R66 SERVICE BULLETIN SB-20B
(supersedes R66 SB-14 and R66 SB-20A)

DATE: 07 November 2016 **REV B:** 20 December 2017

SUBJECT: Tail Rotor Drive Shaft Bearings

ROTORCRAFT AFFECTED: R66 Helicopters S/N 0003 thru 0752. Spare D224-3 tail rotor drive shafts are also affected. Spare D224-4 tail rotor drive shafts are affected by part B only.

FIGURE 1

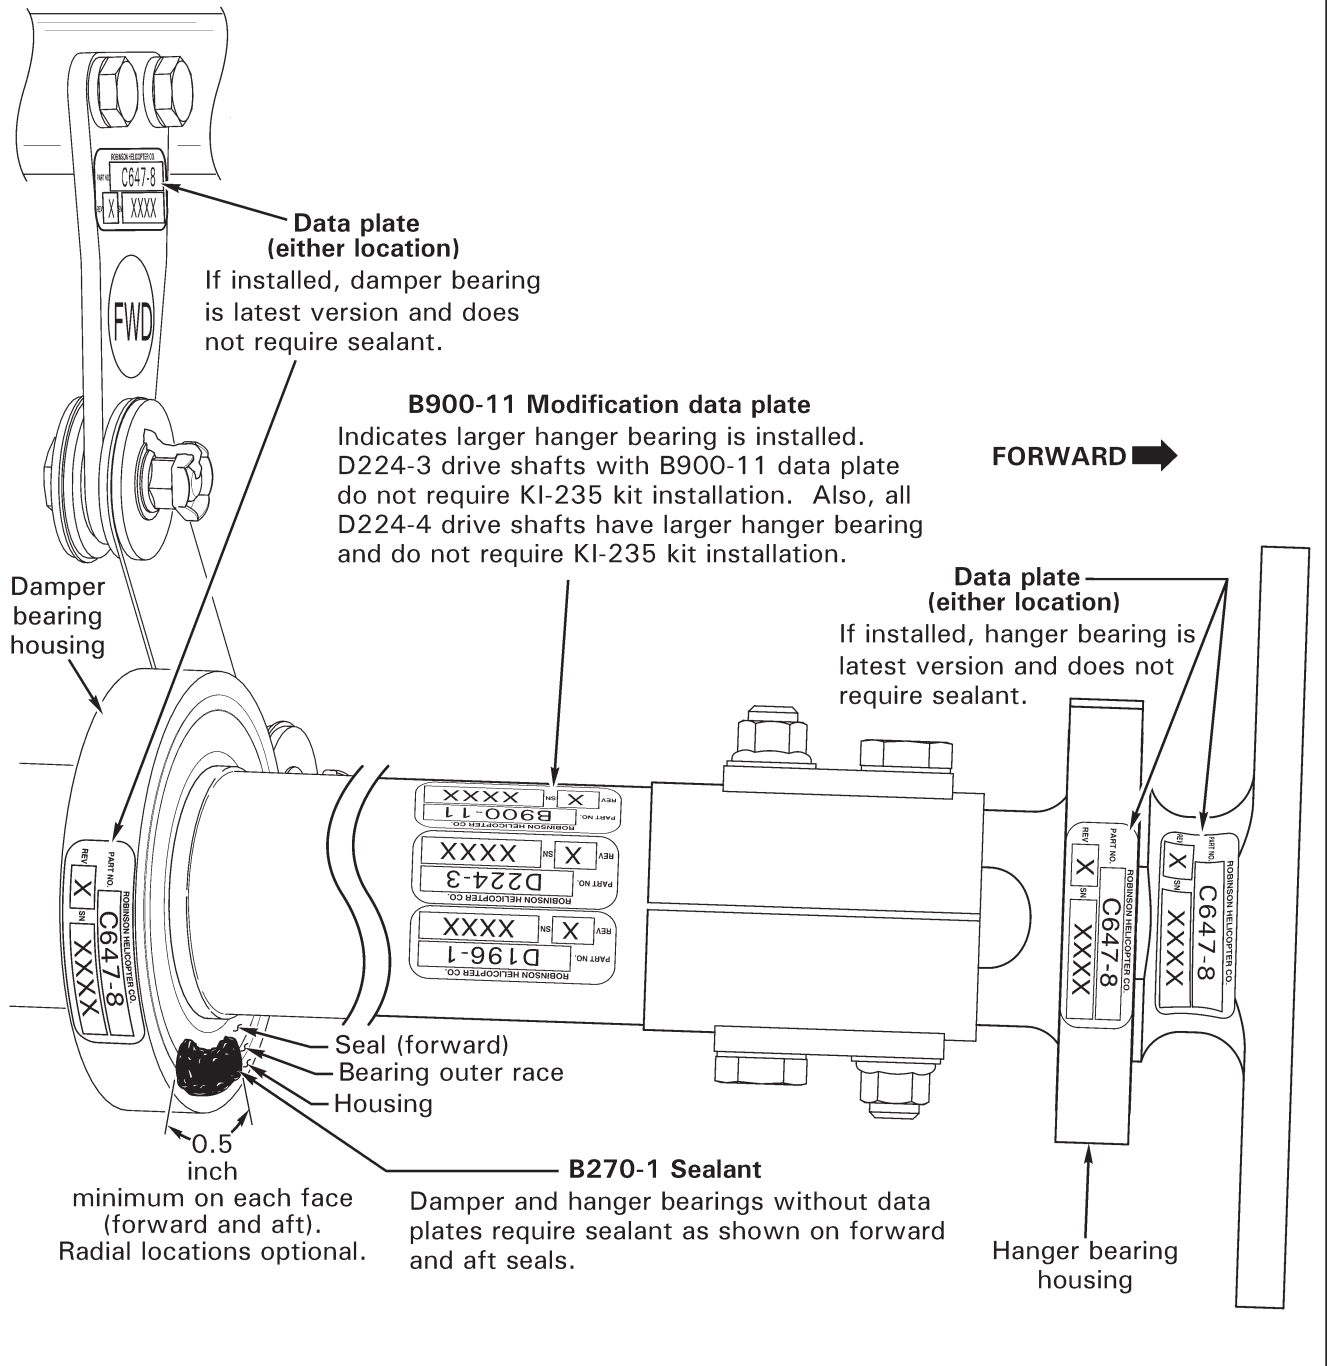
1. Refer to Figure 1. If a D224-3 tail rotor drive shaft assembly **without** a B900-11 modification data plate is installed, order one KI-235 bearing upgrade kit from RHC Customer Service and install kit per kit instructions.
2. Remove (pink-colored) Special Pilot Caution for R66 SB-14, dated 25 June 2015, from Pilot's Operating Handbook.
3. Make appropriate maintenance record entries to reflect compliance with Part A of this bulletin. No change to helicopter weight and balance.

Refer to Figure 1. If a data plate is installed on the C041-13 arm or damper bearing housing, then the damper bearing is latest version and no sealant is required; if a data plate is installed on the D195-3 yoke or hanger bearing housing, then the hanger bearing is latest version and no sealant is required. Bearings without data plates require sealant per the following:

3. As applicable, clean accessible portion of bearings lacking sealant with cotton swabs dampened with acetone. Using a smooth, rounded tool of sufficient length, apply a minimum 0.5 inch long bead of B270-1 sealant at most accessible junction of seal and bearing outer race; sealant contact with housing is permissible. Allow sealant to cure. Sealant is required on both bearing faces (forward and aft).
